City Center Development Agency Board - Agenda

March 3, 2015 - 6:30 p.m.

Agenda Title: Continuation of A+O Apartments Comprehensive Plan
Amendment/Planned Development

P2.2

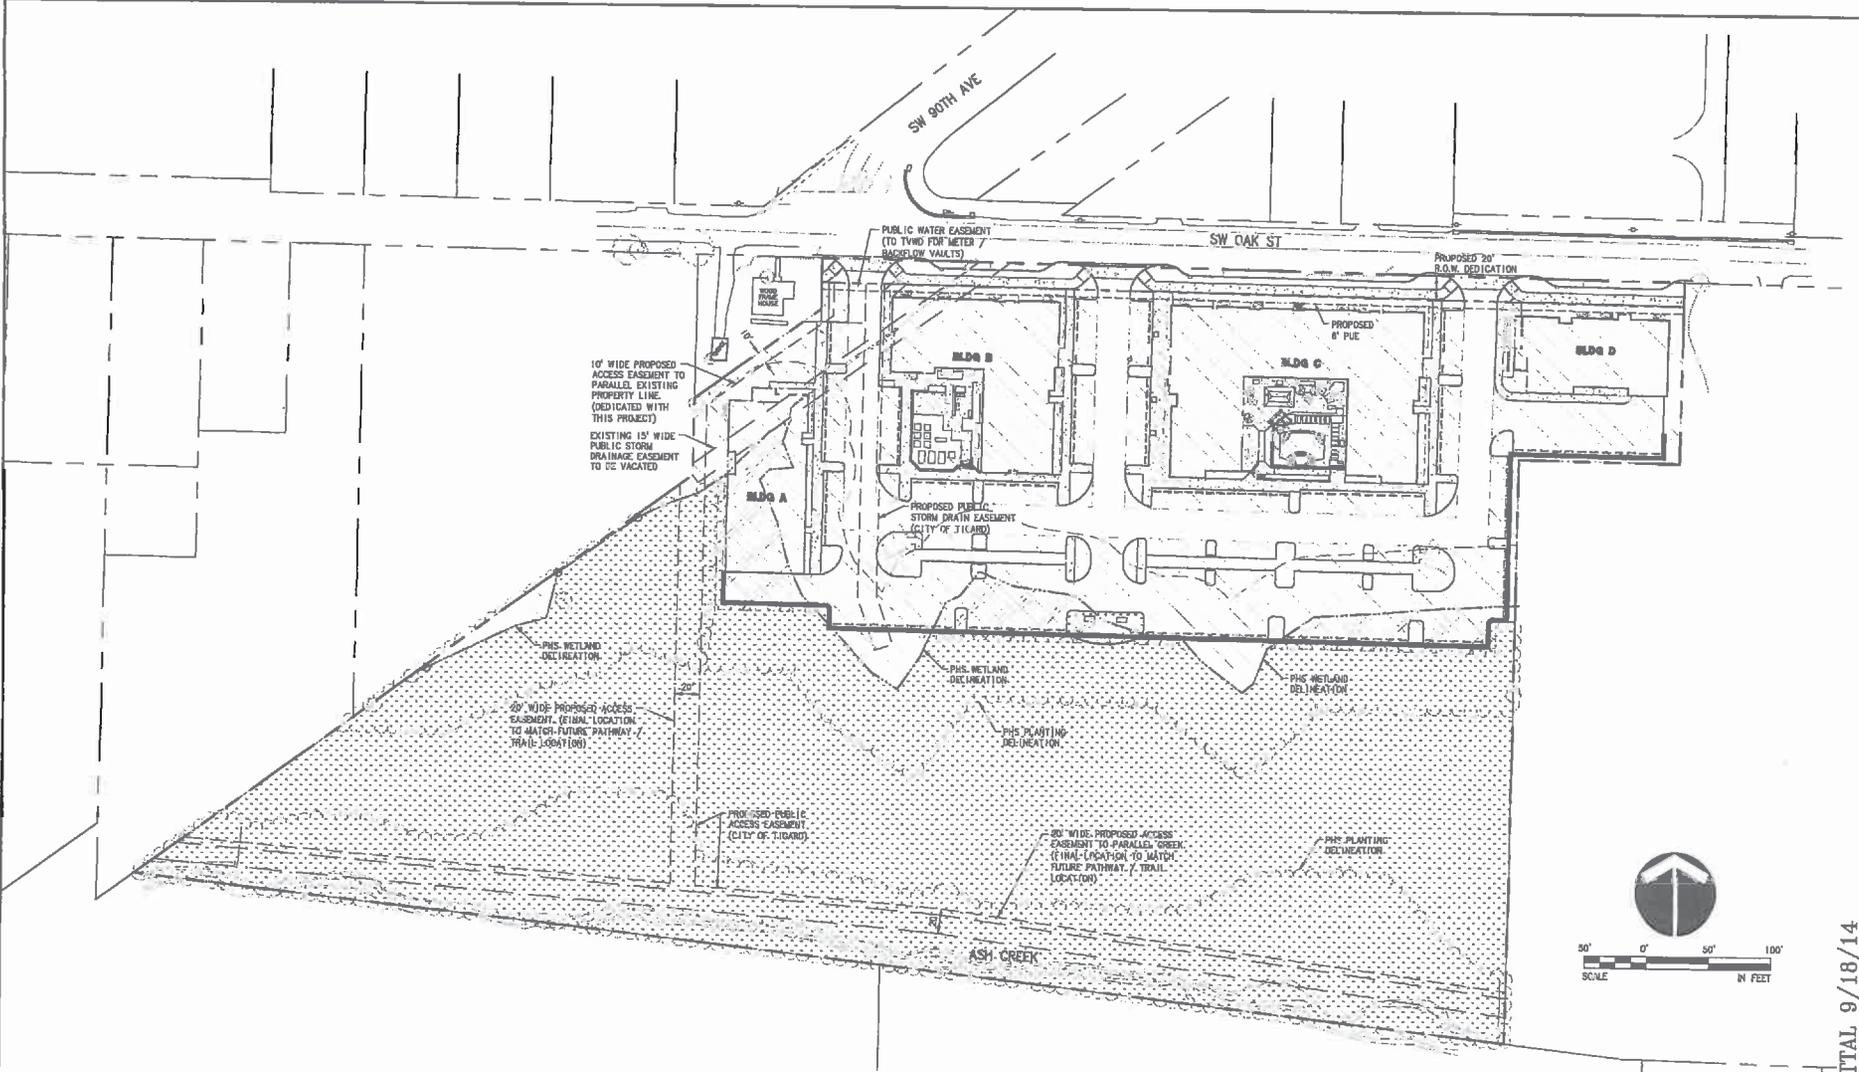
The Planned Development Concept Plan, Sheet P2.2, illustrates areas on the site that are intended to be preserved as open space in the form of wetlands and enhanced wetland; active open space and recreation areas near the proposed building locations; and passive landscape areas. The applicant's narrative, along with the applicable supplemental reports in the Appendix, describe how the natural open space, active open space, and passive open space areas are to be used and how the plans for the 6.2 acres in the southern portion of the site will protect and enhance the natural areas on the site. This criterion is met.

The Planned Development Concept Plan, Sheet P2.2, along with the aerial photo of the site and its environs, Sheet P2.1, illustrates how the proposed development will fit into the street and land use pattern of the neighborhood. This criterion is met.

The plans for the project include the provision of an 8-foot wide sidewalk along the site's frontage. The Planned Development Concept Plan, Sheet P2.2, illustrates the general areas on the site where the applicant is offering to provide public pedestrian easements for the future development of a trail along Ash Creek, and a trail to connect between that trail and the sidewalk along SW Oak Street. Primary pedestrian routes through the site are also illustrated. However, given the applicant's request for a parking exemption of 9.1%, staff recommends that the applicant provide a walkability and ridership assessment that ensures the plan maximizes methods to promote walkability and transit ridership within a quarter mile of the subject site, including but not limited to measures identified in TriMet's comment letter dated December 4, 2014.

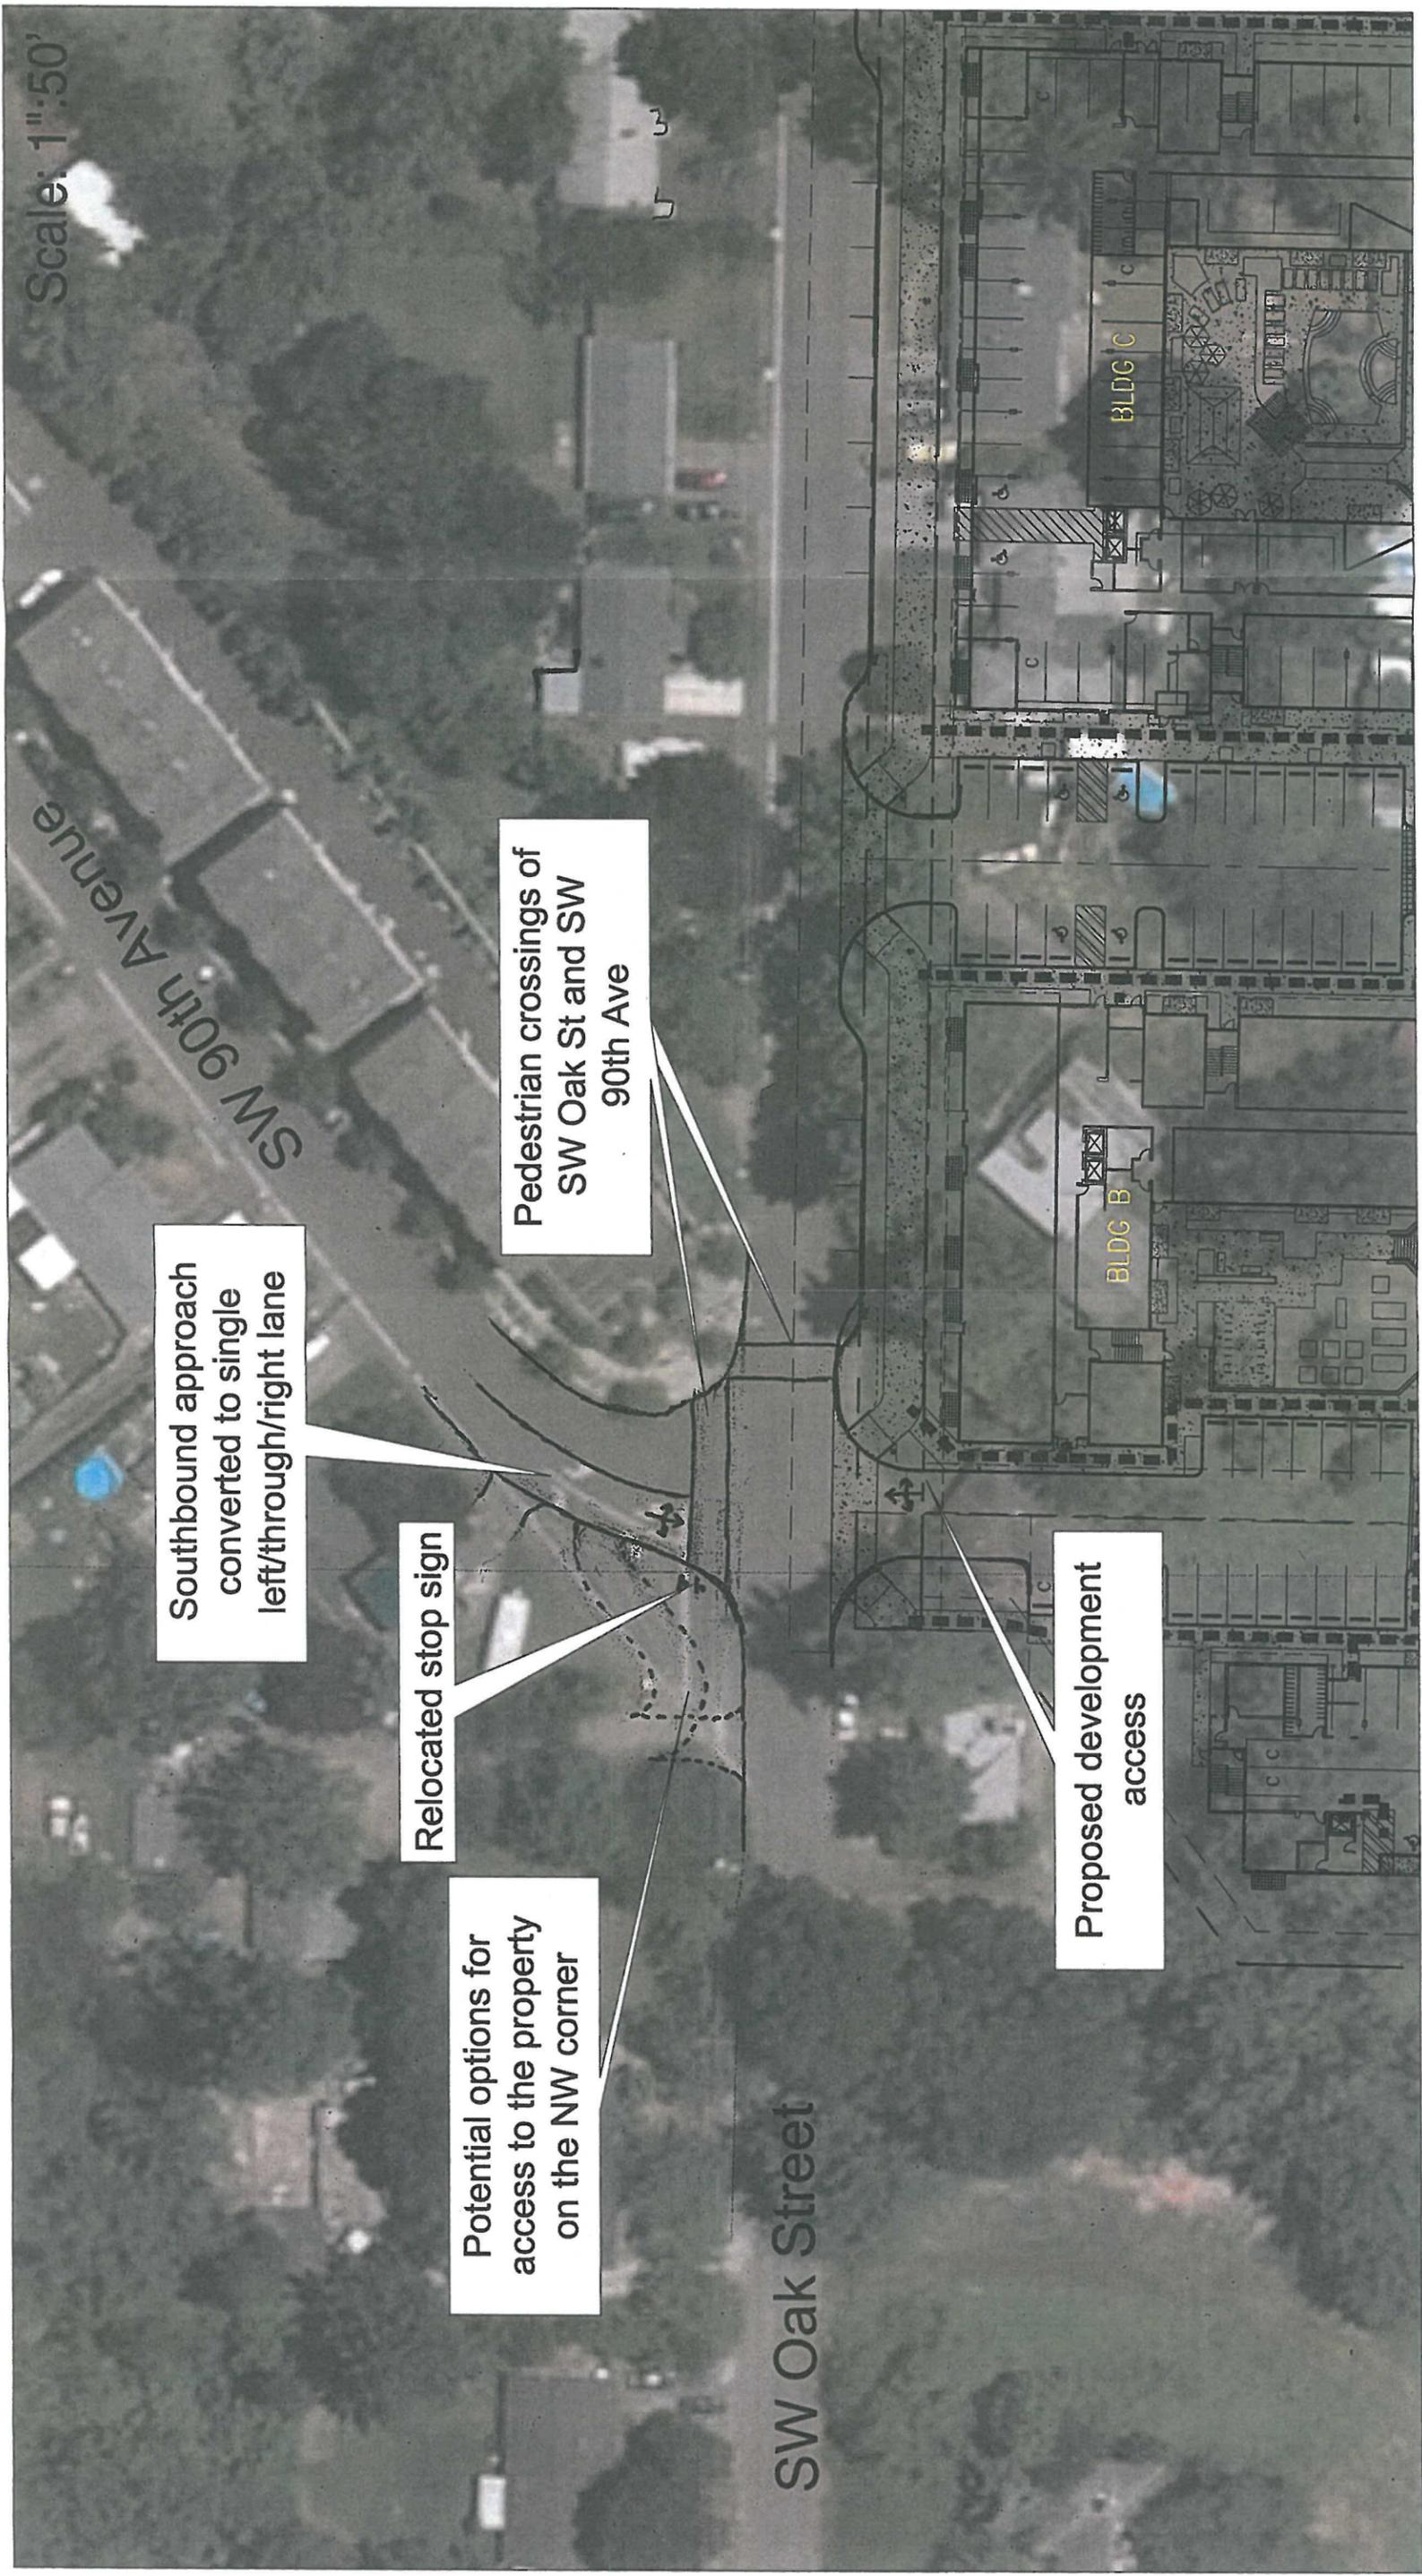
1. Purpose. Architecture helps define the character and quality of a street and can make a strong statement about the overall community and city at large. The placement and design of buildings provides the framework for the streetscape and defines the edges of the public right-of-way. Architecture and ground floor uses can activate the street, either by its design presence or by those who come and go from it. At intersections, investing in building frontages can create gateways and special places that add to the character of the area.

C. Front yard setback design.

1. **Purpose.** The front yard is the most conspicuous face of a building and requires special attention. Places for people and pedestrian movement helps create an active and safer street. Higher level of landscape anticipates a more immediate visual result.
2. **Standard.** For setbacks greater than 0 feet, landscaping, an arcade, or a hard-surfaced expansion of the pedestrian path must be provided between a structure and a public street or accessway. If a building abuts more than one street, the required improvements shall be provided on all streets. Landscaping shall be developed to the applicable standard in subsection E of this section. Hard-surfaced areas shall be constructed with scored concrete or modular paving materials. Benches and other street furnishings are encouraged. These areas shall contribute to the minimum landscaping requirement per 18.520.040.B and Table 18.520.2.

The front yard area between the sidewalk along SW Oak Street and the fronts of proposed buildings B, C and D and parking areas to the sides of buildings will be landscaped with a combination of lawn, planter beds, and trees which will enhance the pedestrian environment along SW Oak Street. This standard is met.
